Access Compliance Report

Public Rights-of-Way

(Curb Ramps)

Intersection ID: 11911	Main Street: W_7TH_ST	Cross Street: N_CHURCH_ST	Location: E
ADA ID: EB79E38C7364	Ramp Type: PerpDiag	Initial Pass/Fail: Pass	Overall Compliance: No
Severity Score: 5			
Codes/Mitigation Info/Possible Solution		Field Measurements/Component Compliance

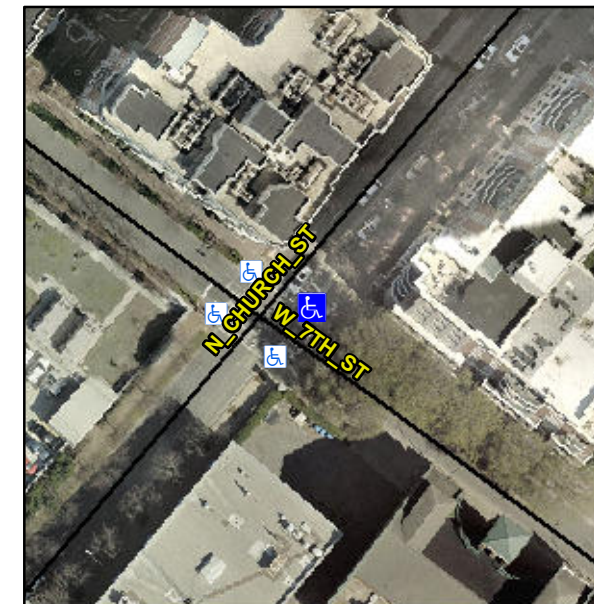
Compliance	Description	Data	Compliance	Description	Data
N/A	Ramp Length (in)	90.0	Yes	Ramp Slope (%)	5.2
Yes	Ramp Width (in)	58.0	Yes	Ramp XSlope (%)	1.2
N/A	Flare Type LT	Sloped	No	Flare Type RT	N/A
N/A	Flare Slope LT (%)	3.4	N/A	Flare Slope RT (%)	N/A
N/A	Flare Traversable LT?	Yes	N/A	Flare Traversable RT?	No
Yes	Landing Length (in)	60.0	Yes	DWS Provided?	Yes
Yes	Landing Width (in)	50.0	Yes	DWS Contrast?	Yes
No	Landing Slope (%)	2.4	Yes	DWS Length (in)	24.0
No	Landing X Slope (%)	3.5	Yes	DWS Full Width?	Yes
N/A	Landing Curb? (Y/N)	No	Yes	DWS Offset (in)	1.5
N/A	Shared Landing?	No			
Yes	Gutter Ponding?	No	Yes	Gutter Slope (%)	1.7
Yes	Gutter Lip Ht (in)	0.0	Yes	Gutter X Slope (%)	0.4
N/A	Painted X Walk1?	Yes	N/A	Painted X Walk2?	Yes
	X Walk 1 Direction	To NW		X Walk 2 Direction	To SW
N/A	X Walk 1 Width (in)	88.0	N/A	X Walk 2 Width (in)	107.0
	X Walk 1 Slope (%)	1.1		X Walk 2 Slope (%)	5.4
	X Walk 1 X Slope (%)	3.6		X Walk 2 X Slope (%)	0.7

Yes	Ramp inside XWalk1?	Yes	Yes	Ramp inside XWalk2?	Yes
	Road Slope (%)	1.7	N/A	Clear Space?	Yes
	Road X Slope (%)	0.9	Yes	Clear Space to XWalk (in)	50.0
Yes	Any Obstructions?	No	Yes	Storm Grate/Utility Hazard?	No
	Obstruction Type			Storm Grate/Utility Type	
		N/A			N/A
			Yes	Surface Condition? (G/P)	Good

Remove & Replace Curb Ramp With Two New Directional Ramps or Equivalent.
